SAXTON NUCLEAR FACILITY

Operating License No. DPR-4  
Docket No. 50-146  
Technical Specification Change Request No. 53, Rev. 2

REQUEST FOR ADDITIONAL INFORMATION  
SAXTON NUCLEAR EXPERIMENTAL CORPORATION  
DOCKET NO. 50-146

FIGURE 1

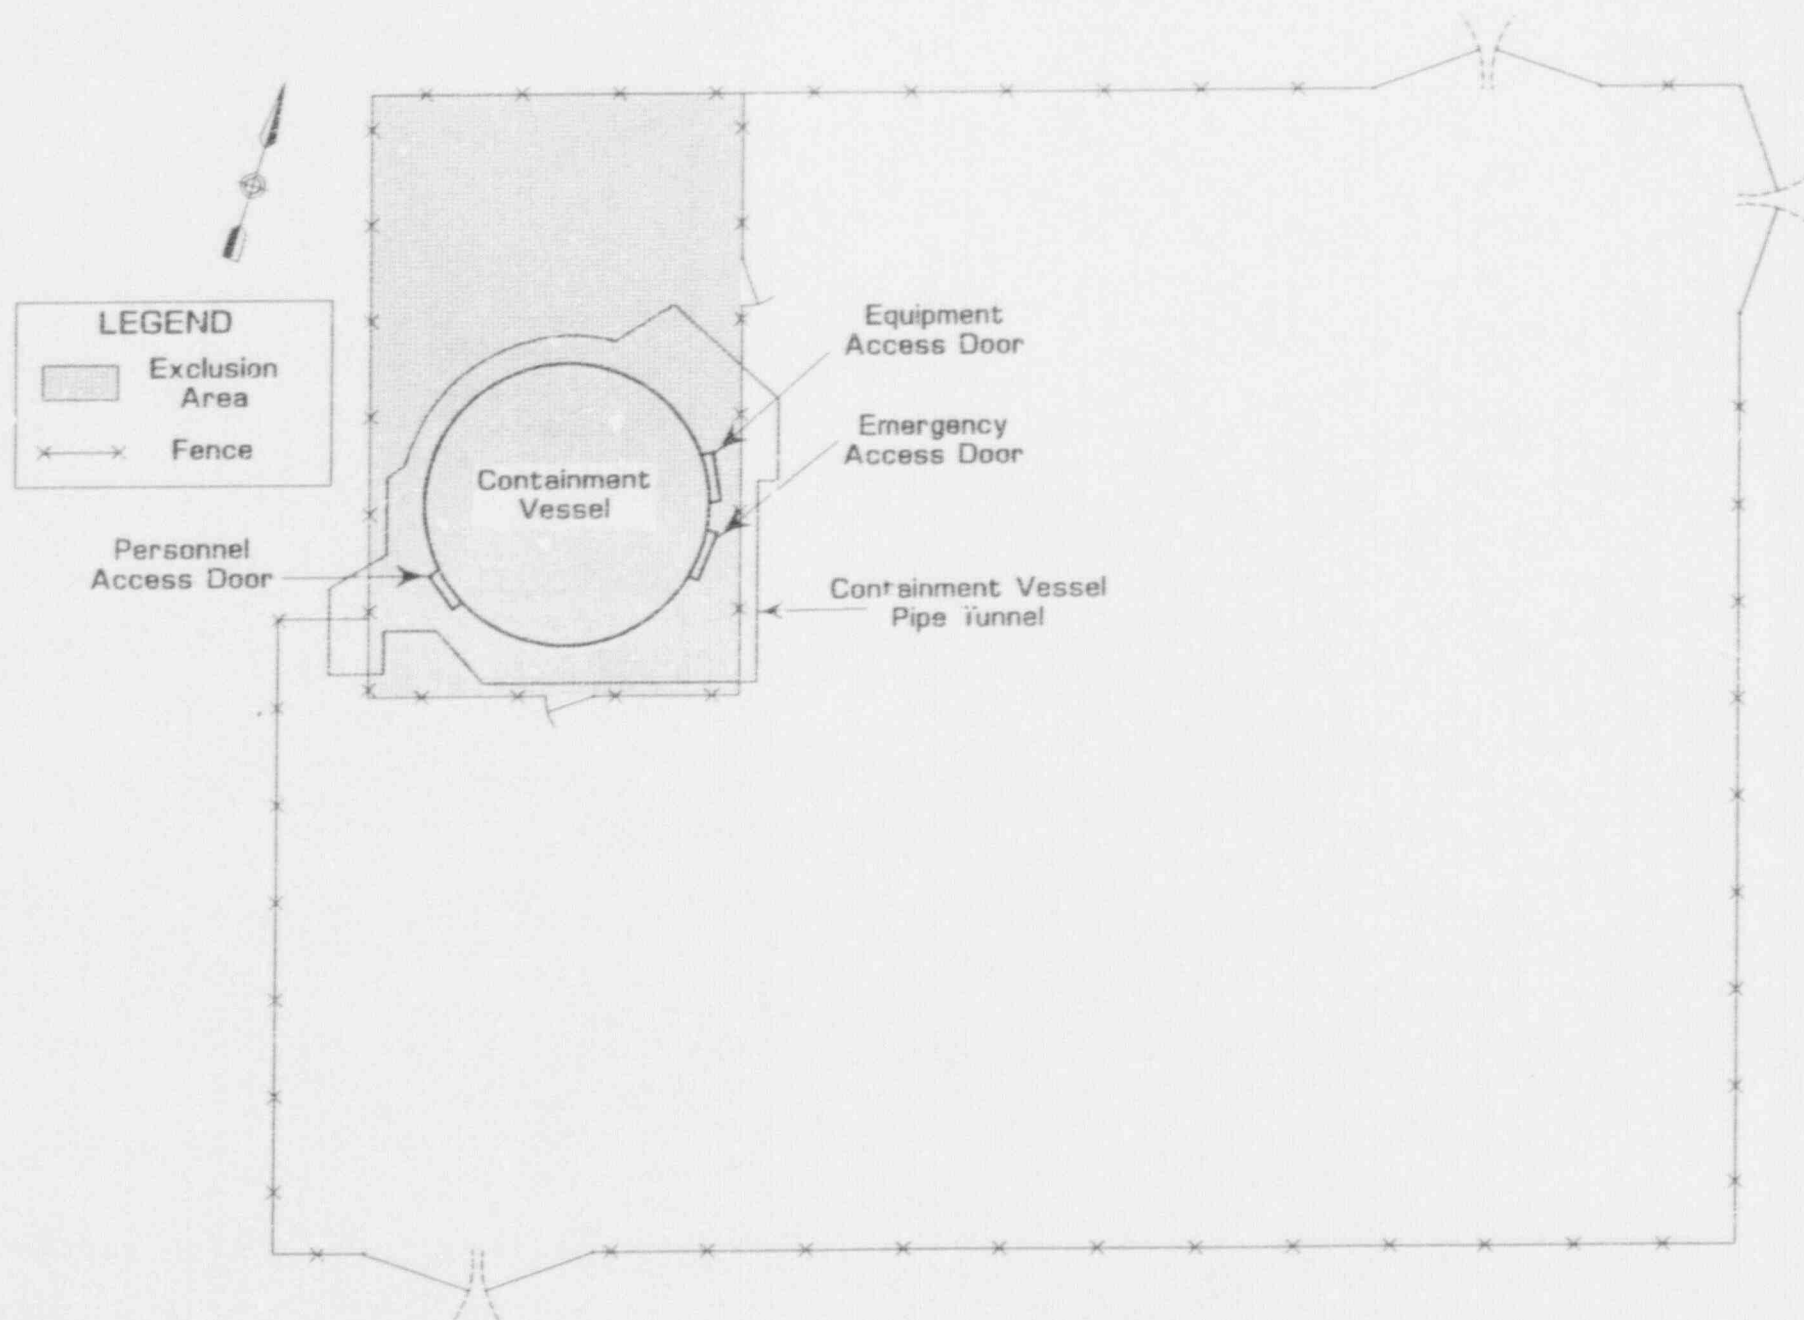
7. During our meeting of February 3, 1992, you stated that a new fence was erected in front of the Control and Auxiliary Building. Please update Figure 1 to reflect the new fence.

TS Figure 1 has been revised to show the new fence erected in front of the C&A building.

**RESPONSE:** Figure 1 in TSCR No. 53, Revision 2 has been updated to reflect the new fence.
